**PHOTOGRAPHS**

**BUILDING 20  
SECTION D**

**PHOTOGRAPH #3**

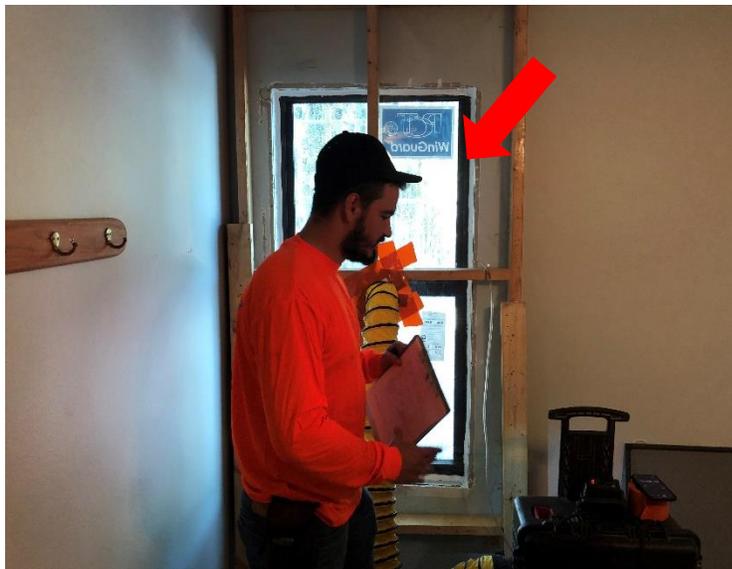
Independent testing agency performed and passed AAMA 502 water testing at 2<sup>nd</sup> floor single window.

**PHOTOGRAPH #9**

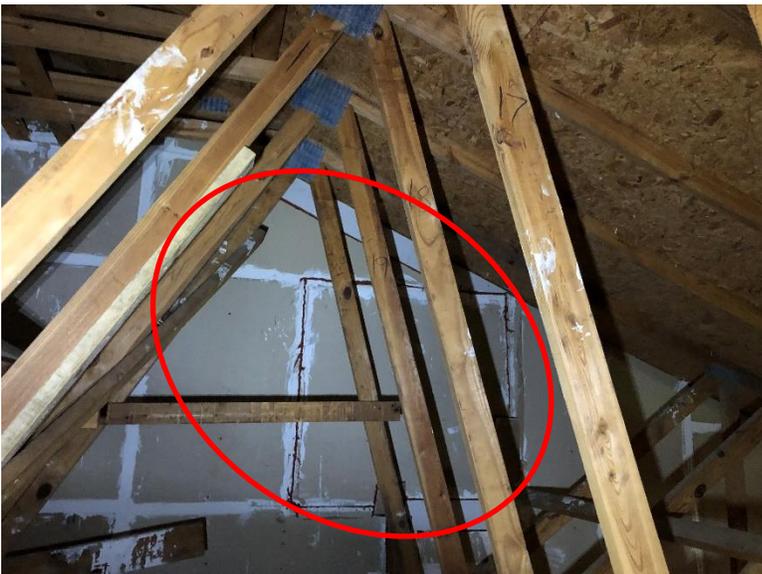
Truss scabs, gussets and fire wall repairs performed.
